Beaver Creek Alaska Subdivision 2020 Replat

ITEM 7 – BEAVER CREEK ALASKA SUBDIVISION 2020 REPLAT

KPB File No.	2021-006
Plat Committee Meeting:	May 23, 2022
Applicant / Owner:	Freedom Indeed LLC and Luke Saven LLC, all of Kasilof, Alaska
Surveyor:	John Segesser / Segesser Surveys
General Location:	Kenai Spur Highway and Beaver Loop Road, City of Kenai

STAFF REPORT

PRELIMINARY PLAT

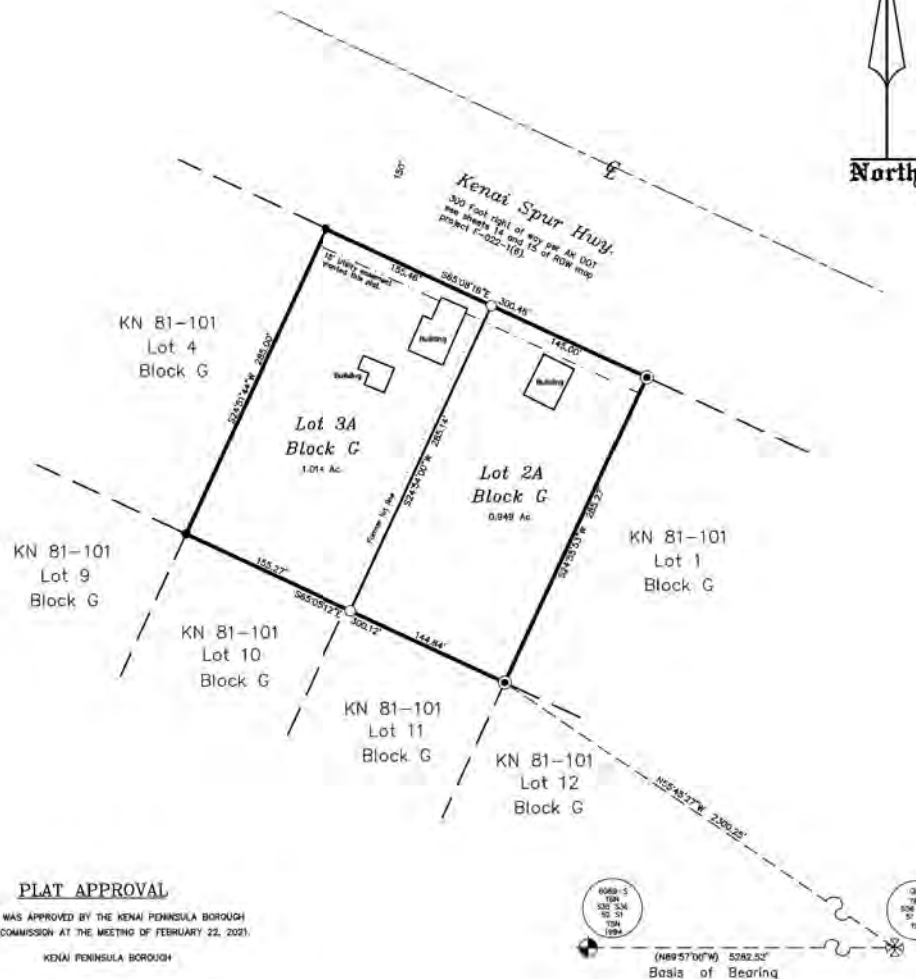
The lot line is moving approximately 5 feet between the parent lots but a wastewater review is not on file for the parent subdivision and the parent subdivision was not approved by AK DEC or KPB under chapter 20.40.

Approval will require a new plat note for the exception granted and a correction to the wastewater disposal note present on the plat. The mylar has been signed and will require reprinting and obtaining new signatures prior to recording.

1. KPB Code requires a soils analysis report unless specific criteria is met.
2. The parent subdivision was not signed by Department of Environmental Conservation.

3. The Kenai Peninsula Borough does not have a soils analysis report for the parent subdivision.
4. The parent subdivision was recorded in 1981.
5. The lot line is moving approximately 5 feet to the east.

6. The replat was to bring the lots into compliance with City setback requirements for the General Commercial Zone.
7. Lot 3A is increasing by approximately 1,425 square feet.

Staff recommendation: place notes on the final plat indicating any exceptions granted by the Plat Committee with the meeting date and provide the correct Wastewater Disposal note.
